GROVE CITY, OHIO - CITY COUNCIL Agenda

November 18, 2024

AN ORDINANCE TO ACCEPT THE PLAT OF HICKORY CREEK, SECTION 1

**RE: *Hickory Creek S1 Plat
Planning Commission Resubmittal
Review Comment Letter Responses***

Proposed Building #2 - 65'x150'
(9,750 SF)

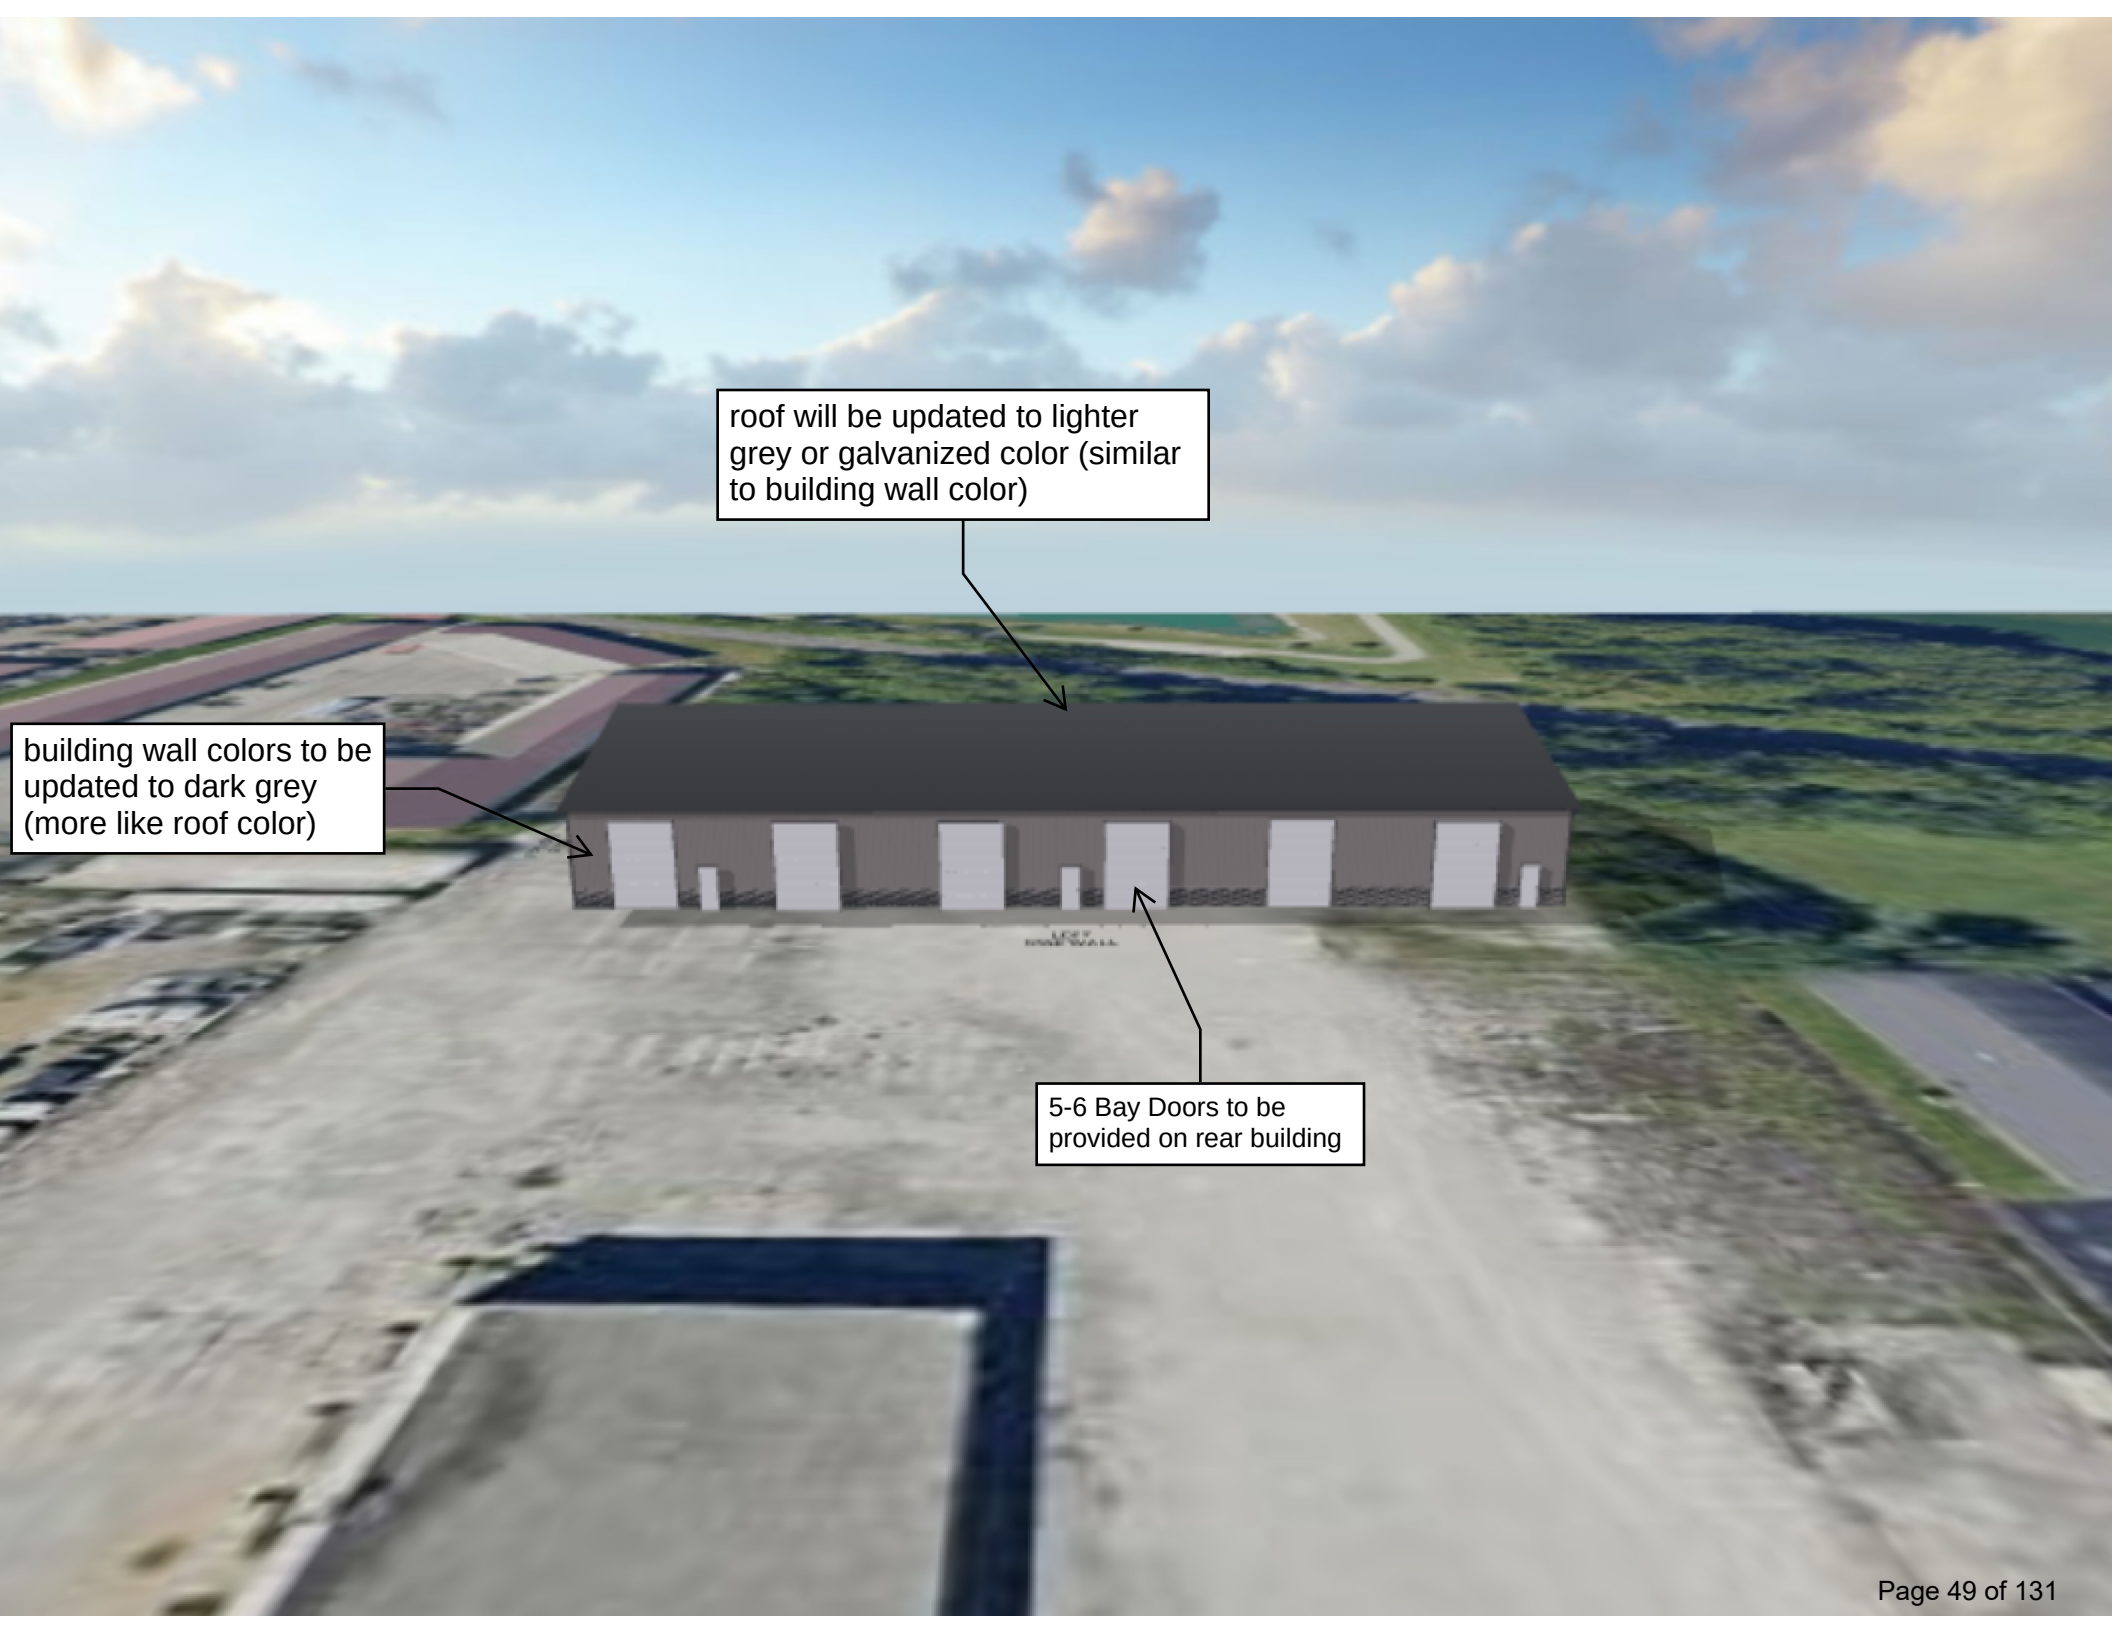
building wall colors to be
updated to dark grey
(more like roof color)

5-6 Bay Doors to be
provided on rear building
